Coney Island West Parcel A RFP

Project # 11122

Q&A #2

April 23, 2025

MAP NO. X-2716

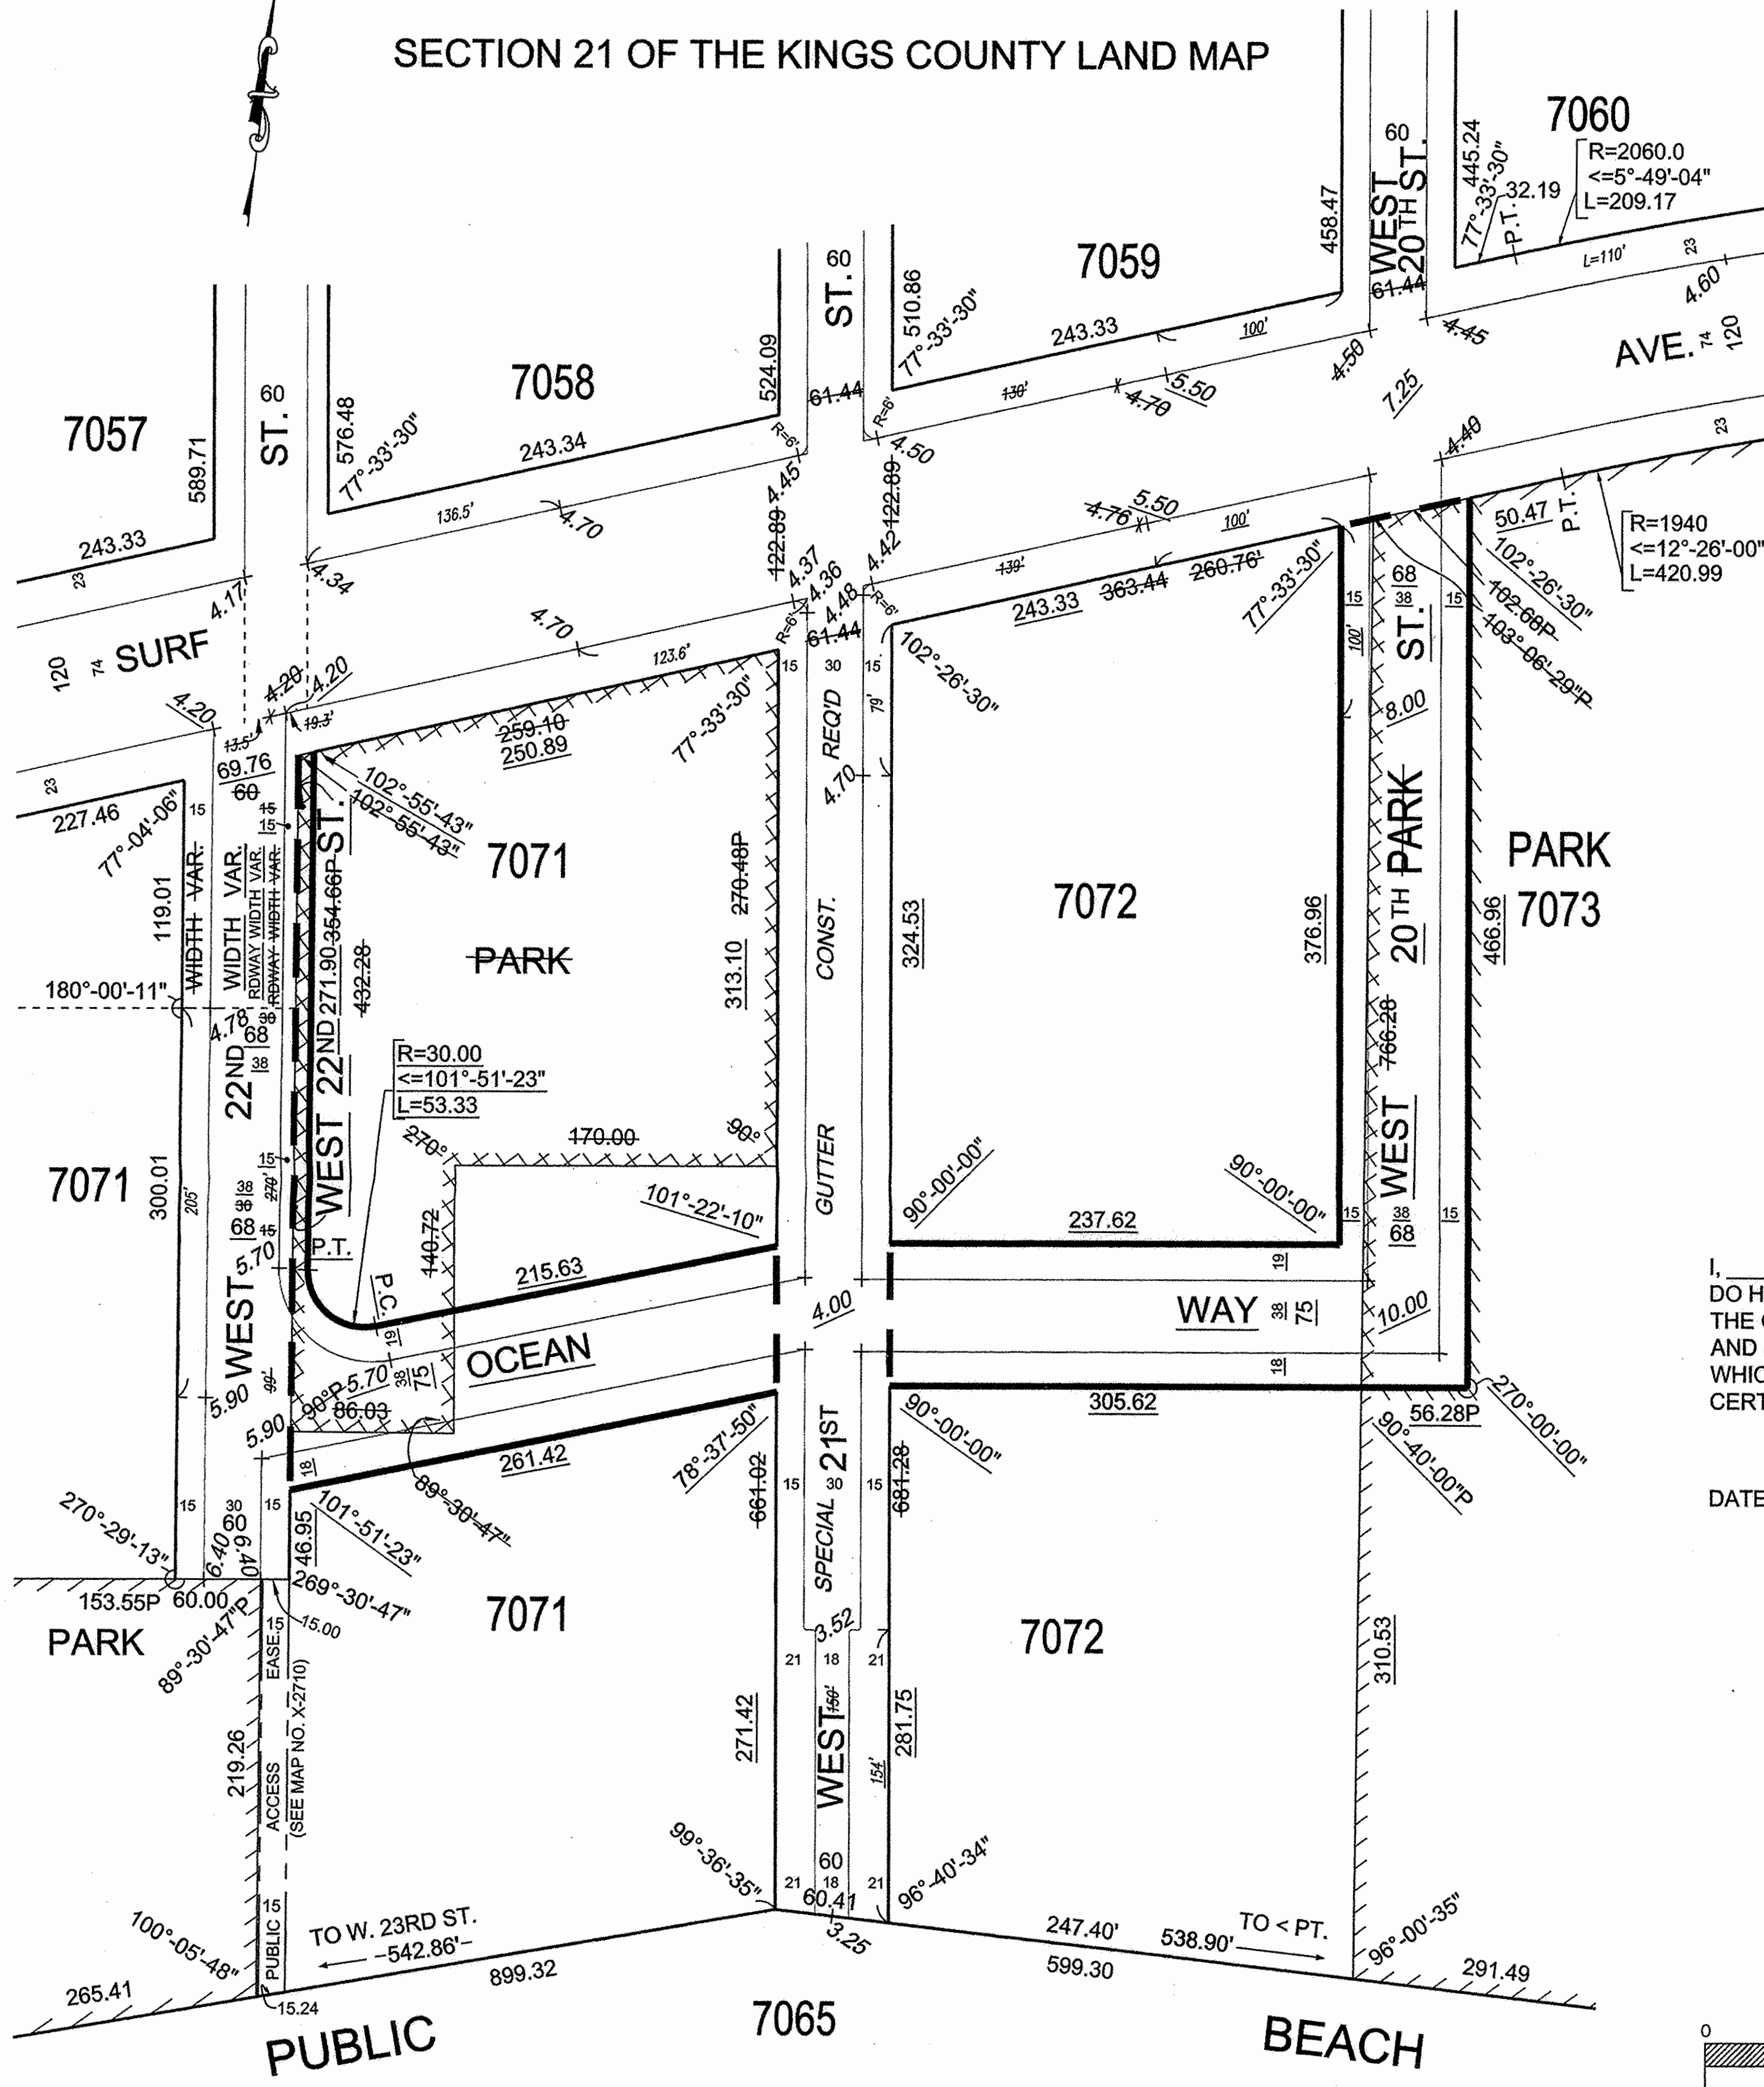
- 3. Q: Does NYCEDC have access to a site survey that shows the dimensions of the proposed lot line?**

- 4. Q: West 21st and West 22nd are currently two-way streets. Will they become one-way after the development or remain as they are? And what about the Ocean Way?**

A: Please see the approved map X-2716 attached to this document. The map displays the dimensions of Parcel A.

A: West 21st, West 22nd, and Ocean Way will be two-way streets after the development of Parcel A.
